DEPARTMENT OF PUBLIC WORKS
CITY AND COUNTY OF HONOLULU

ENGINEERING AND POLICY MEMORANDUM NO. 1-86

TO: ALL ARCHITECTS, ENGINEERS, DEVELOPERS AND CONTRACTORS
FROM: RUSSELL L. SMITH, JR., DIRECTOR AND CHIEF ENGINEER
SUBJECT: SIDEWALK DETAILS, SHEET R-28, STANDARD DETAILS
FOR PUBLIC WORKS CONSTRUCTION

SIDEWALK WITH STANDARD CURB & GUTTER

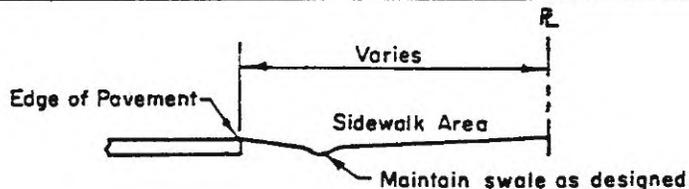
Effective immediately, the design and construction of sidewalks shall comply to the attached revised Standard Detail Sheet R-28. An additional note has been inserted to permit deviations from sidewalk standards when approved in writing by the Chief Engineer.

Except for this note allowing deviations, all other notes and requirements on sheet R-28 of the Standard Details for Public Works Construction remain unchanged.

- In areas where curbs exist with unpaved sidewalks, temporary asphalt concrete walkways may be installed, if authorized by the Chief Engineer.
- Deviation from this standard and other sidewalk standards may be permitted upon written approval of the Chief Engineer.
